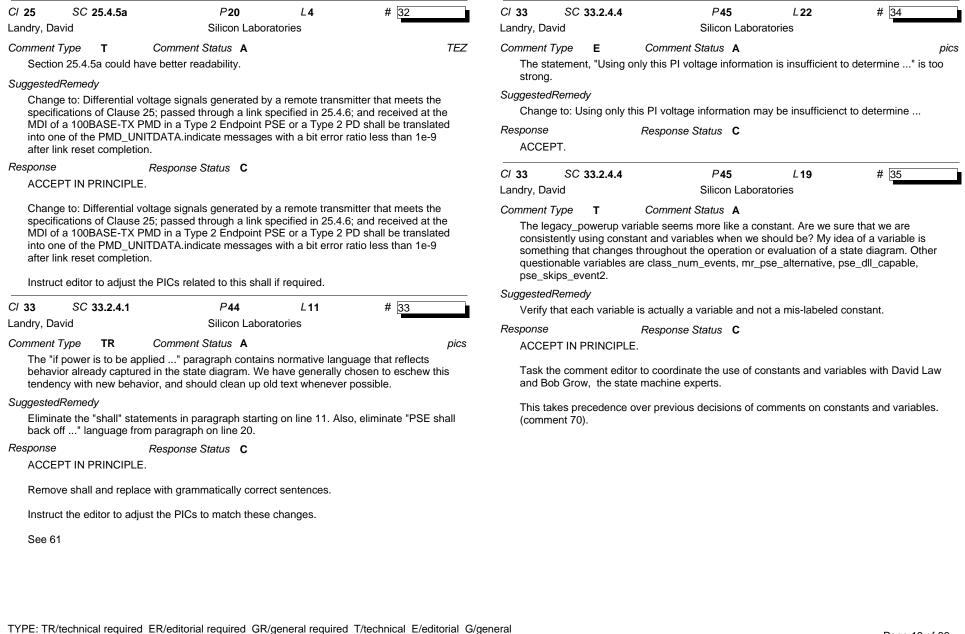
This comment was WITHDRAWN by the commenter.	Figure 33-18.
	Proposed Response Response Status Z REJECT.
It is already undefined and out of scope. There is no need to enumerate all the things undefined and out of scope.	This comment was WITHDRAWN by the commenter.
	The existing DO_CLASS_EVENT3 permits multiple cycles.
	The transient behavior of the link is not incorporated in the state machine - Vport_PD is defined as a static value. Thus there is no need to create a lot of extra states.
